From: [Stephen Ubl](#)
To: [Marcia Moermond](#)
Cc: [Nathan Bruhn](#)
Subject: FW: 733 Fairview Ave. N.
Date: Monday, March 11, 2024 1:04:54 PM
Attachments: [image005.png](#)
[image006.png](#)
[image007.png](#)
[image008.png](#)
[image009.png](#)
[image010.png](#)

I have been told that you are engaged in a project at 733 Fairview Ave. N., a building identified as a Vacant Building Category III. If you have questions regarding Plan Review, Permitting, Inspections, or Appeals, please reach out to me and I can see what I can do to move this project along.

**TOUGHRock**

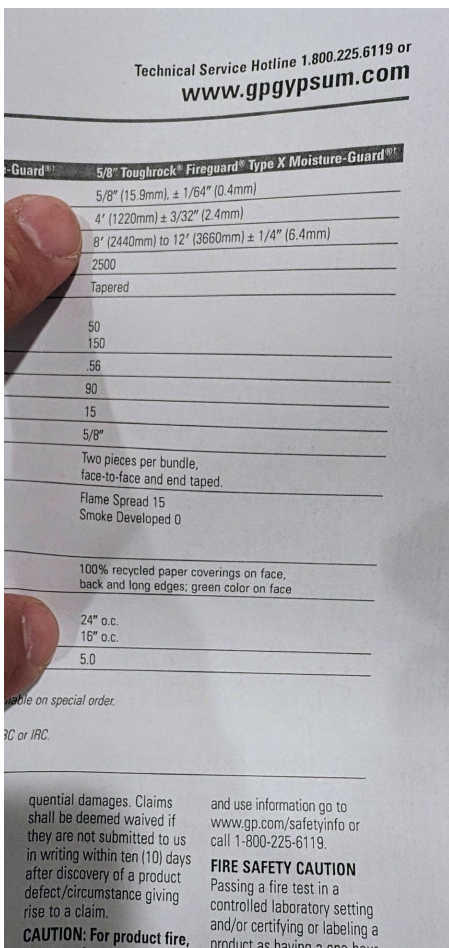
To this end, as illustrated in the Georgia-Pacific manufacturer's installation recommendation instructions for the 5/8" Toughrock Fireguard ("green" board) Type X Moisture Guard gypsum sheetrock that has been installed in the 733 basement ceilings, Framing Spacing, Maximum for Ceilings is **16" o.c., not 12" o.c.**

To this end, the basement 5/8" ceilings at the 733 Fairview Ave. N. property remain in compliance with both the CertainTeed ("purple" board) and the Georgia-Pacific ("green" board) manufacturer's installation recommendations of a minimum of 16" o.c.

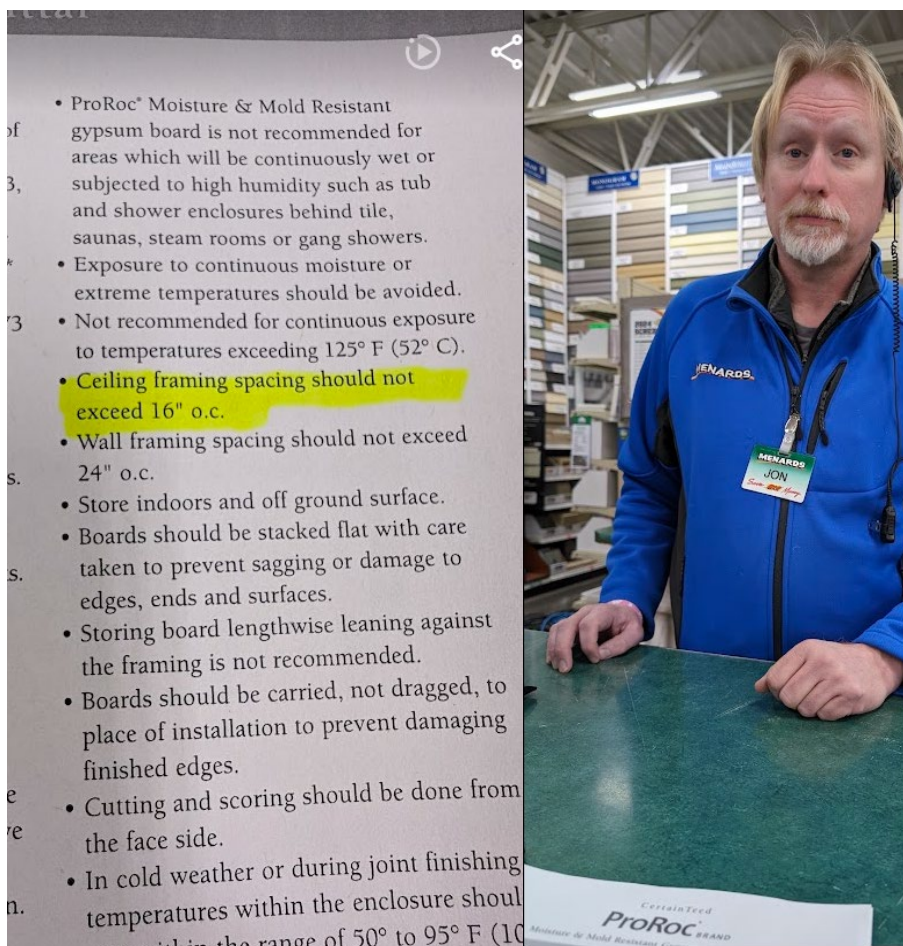
Tuesday, after our meeting, I went to Menards. I eventually was able to speak with Jon, in the building center, who is familiar with my situation. I asked him to provide me with the literature on the manufacturer's installation instructions for the moisture-mold-resistant sheetrock to determine whether what I did in my home complied with the manufacturer's installation recommendations. I asked him specifically whether the moisture & mold resistance gypsum board he sold me from Menards to install on many of the walls and ceilings, per the manufacturer's instructions, called for it to be installed on 16" on center or whether it required a lesser distance. Without saying a word, Jon got on his screen, printed, and with his yellow highlighter, marked the following and slid the paper over to me: "Ceiling framing spacing

should not exceed 16" o.c." Based on the above, I complied with the manufacturer's gypsum board moisture-mold-resistant installation recommendations, Stephen.
